**Edwin I. Hatch Nuclear Plant  
Transmittal of Responses to  
License Renewal Draft Open Items**

**ENCLOSURE 1**

**CONSOLIDATED SNC RESPONSES FROM ELECTRONIC COMMUNICATIONS**

**TORUS SECTION VISUAL AID PROVIDED TO SUPPORT RESPONSES TO  
POTENTIAL DRAFT SER OPEN ITEMS 41, 42, AND 46**

**SECTION THROUGH TORUS  
E.I. HATCH NUCLEAR PLANT**

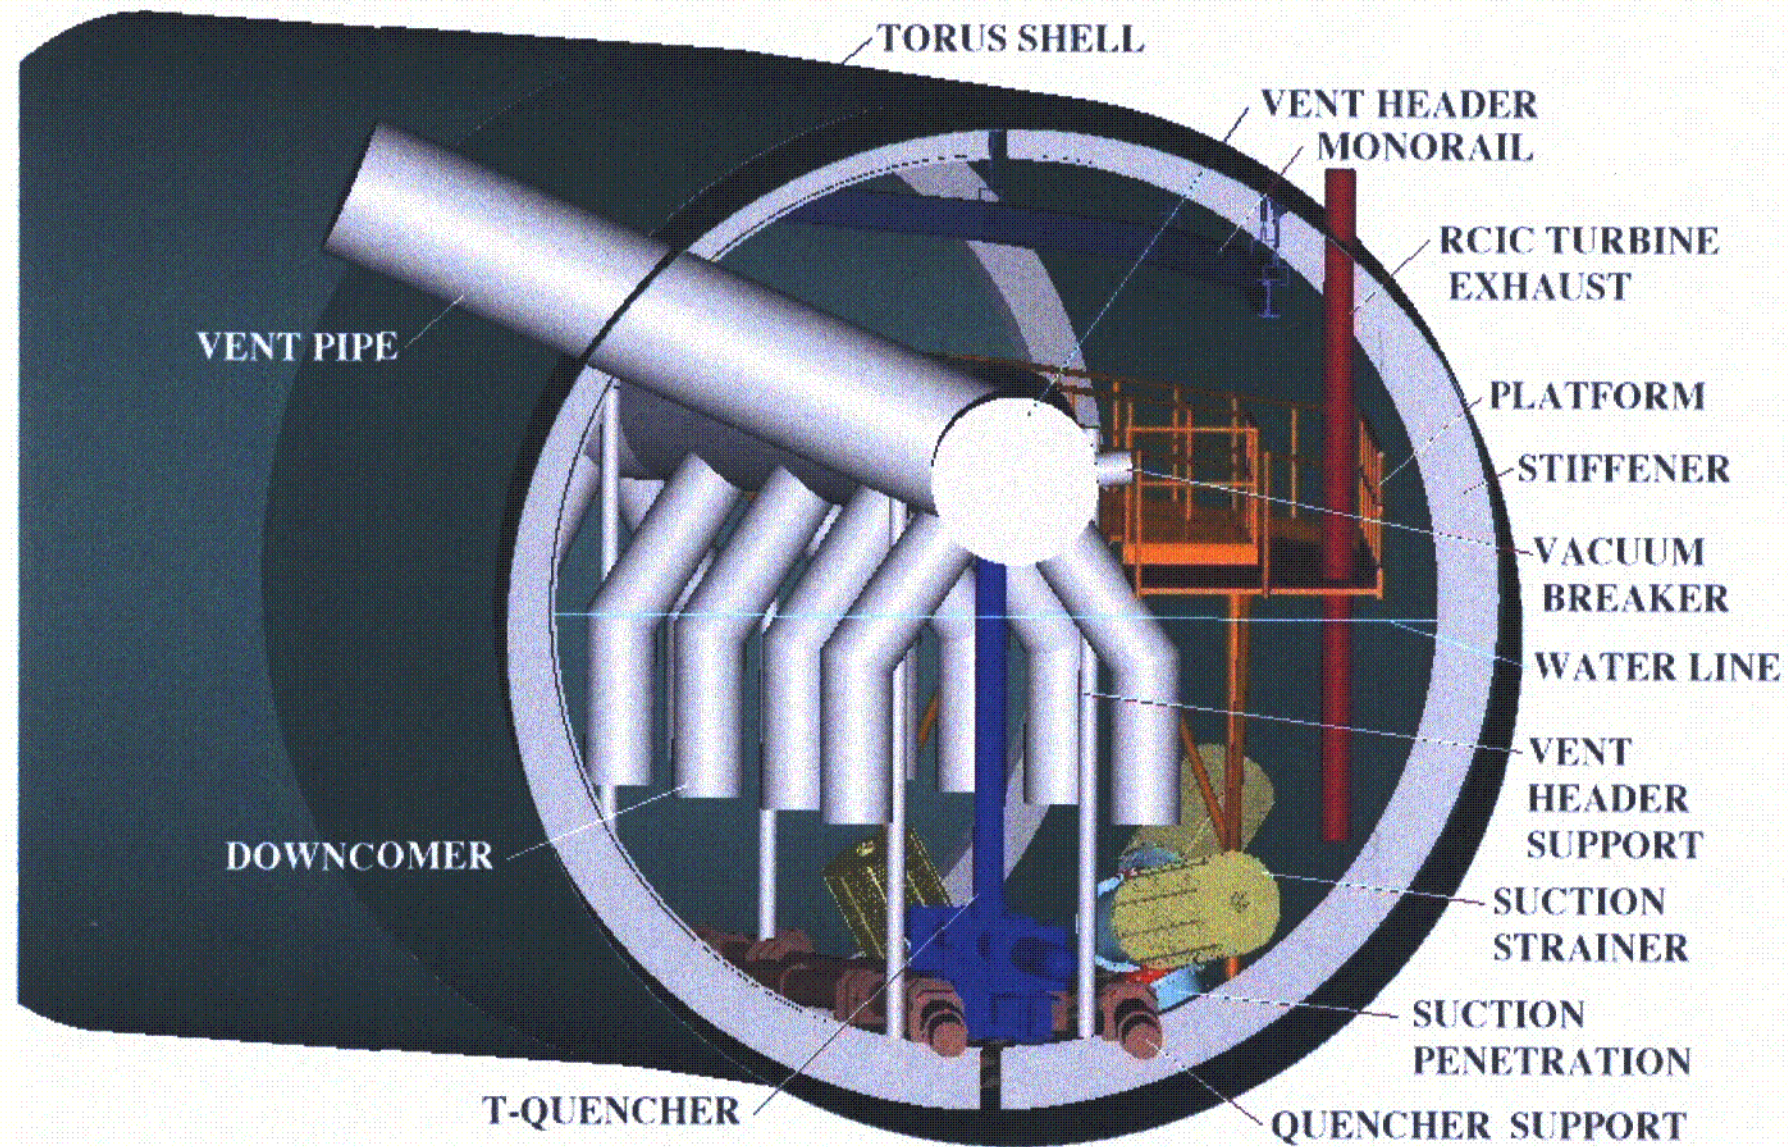
In response to the RAI 3.6-36 related to the aging management review of penetrations in the torus, the applicant points out that they are covered under primary containment penetrations in Section C.2.6.2 of the LRA, together with the aging management review of drywell penetrations. Many penetrations in tori are submerged in torus water, an

environment distinctly different from that of the penetrations in drywell, and they require different ISI, coating and leak testing procedures. The staff requests SNC to provide justification why the torus penetrations should not be placed in a commodity group other than that for other components in the primary containment (i.e. drywell).

A visual aid, in the form of plant drawings (H-15002 for Unit 1 and H-25003 for Unit 2), will be provided separate from this e-mail to show a cross-section of the torus and the locations of the torus penetrations in the immersion (submerged) area. Penetrations are not specifically listed in Section C.2.2.3 of the LRA; however, penetrations, being made of the same materials, are considered to be among the items included in the aging management programs for components submerged in torus water. A list of the penetrations in the torus immersion area is shown below. No aging issues unique to submerged penetrations have been identified in the operating experience of the torus.

specifically indicated that SNC would provide a visual aid in the form of two plant drawings to assist NRC staff in the review of the aging management programs for the torus. However, SNC proposes to amend that response by providing the attached artist's rendering of the torus section, along with associated aging management programs. This visual aid is consistent with the discussions held on December 18, 2000 regarding complexities associated with review of aging management activities for the torus. These issues are expressed in potential open items 42 and 46. Thus, SNC provides the visual aid as Enclosure 4 in support of all three potential open items.
